**RECORD OF APPROVAL
14 CFR PART 150
NOISE COMPATIBILITY PROGRAM**

**LOUISVILLE INTERNATIONAL AIRPORT
LOUISVILLE, KY**

**RECORD OF APPROVAL
LOUISVILLE INTERNATIONAL AIRPORT
Louisville, KY**

RNAV RWY 17R

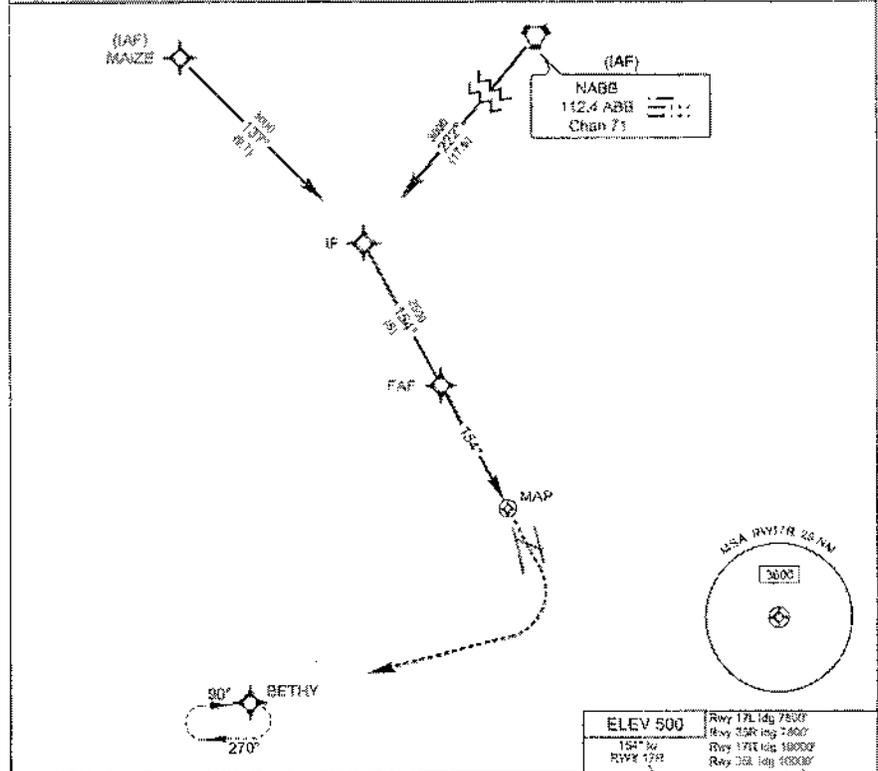
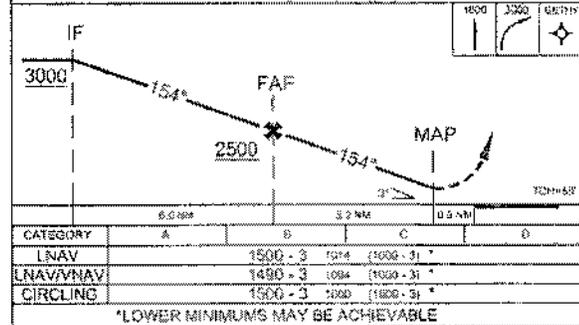
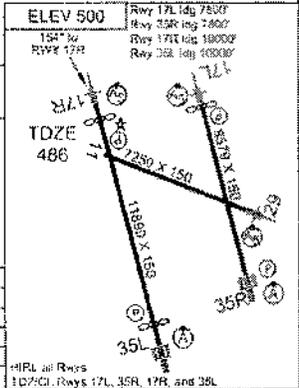
- The Flight Standards Division does not consider this procedure to be a safe operation. The stabilized approach would be compromised, and the missed approach (particularly with loss of engine power) would be under less than ideal conditions and would place the aircraft over a populated area close to the surface, as well as the parallel runway, while maneuvering in a non-favorable environment.
- The Quality Oversight and Technical Advisory, National Flight Procedures Office does not support development of the offset approach due to runway alignment and stabilization criteria, as well as an excessive required missed approach climb gradient.

- The flight path of the proposed offset procedure would place the published missed approach procedure in conflict with arrivals and departures operating from RWY 17L/35R. This would create a significant safety risk. In addition, IFR arrivals from the east, destined for the offset approach, would be required to cross the straight-in final approach course for both Runways 17L and 17R before entering the pattern for the offset approach, which would result in an increased safety risk, along with an increased risk of separation errors.

- Use of an offset approach would eliminate Air Traffic control (ATC) ability to run simultaneous approaches to Runways 17L and 17R. This existing ability is key to an expeditious arrival traffic flow, and was one of the criteria used when designing the airport layout. Simultaneous approaches require that the approaches be parallel precision approaches. An offset approach to RWY 17R is neither parallel nor precise, and does not meet this criterion.

- An offset approach would require the use of increased separation standards, and result in substantial delays for arriving aircraft. It is estimate that an "offset" instrument approach procedure would restrict arrival capacity by approximately 1/3 during instrument (non-visual) weather conditions. Further reductions in capacity would result from the necessity to move the downwind leg of the Runway 17R approach approximately 5-7 miles beyond its normal location in order to accommodate this approach. This inefficiency would be exacerbated if Runway 17R were the preferred runway for all instrument arrivals, as proposed in NA-7.

Based on your request and the aforementioned comments resulting from our technical analysis, the noise abatement measure NA-7, Use an Offset Departure from Runway 35L and Offset Approach to Runway 17R, is disapproved, from a procedural standpoint. In addition, the other noise abatement measures dependent on the Offset Approach, NA-2, Reverse East-West Preference and NA-3, Morning North Flow Preference are also disapproved. This proposal cannot be implemented without reducing the level of aviation safety provided and adversely affecting the efficient use and management of the navigable airspace and air traffic control systems. This disapproval does not constitute a determination under Part 150 which will be completed by the Memphis Airports District Office. They will be contacting you to revise the Record of Approval to reflect these disapprovals in accordance with Part 150.
